Product/Process Change Notice

PCN Title:	Change of Legacy Maxim Integrated Packaging Shipment Labels
Publication Date:	15-Mar-2024
Effectivity Date:	Immediate
Revision Description:	Initial Release

Barcode Labels – Shipping Box

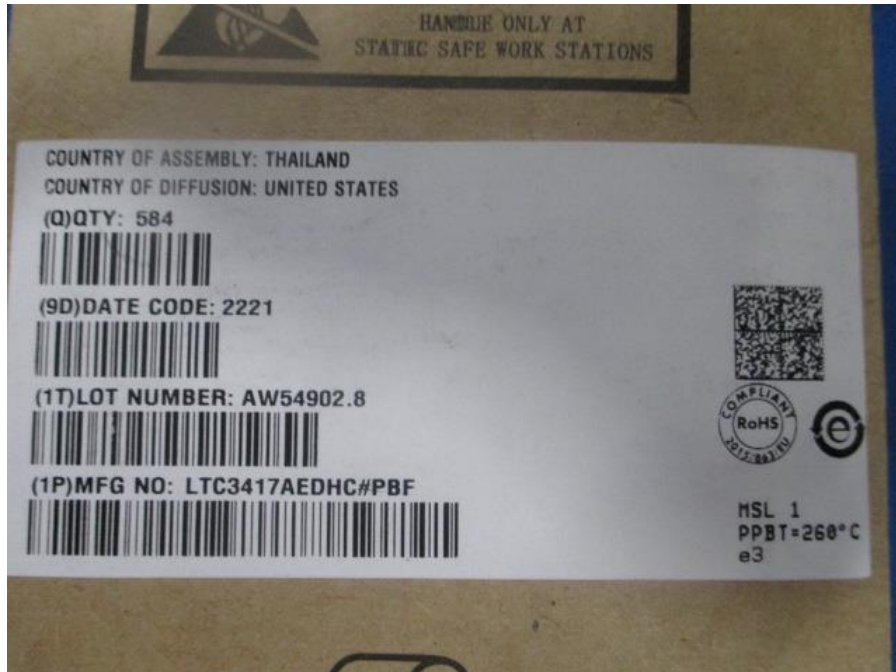
Change to the existing packaging labels for all legacy Maxim Integrated products.

- Customers will receive shipments with standard ADI barcode.
- Any custom barcode requirements have already been agreed to with ADI.

▶ New labels
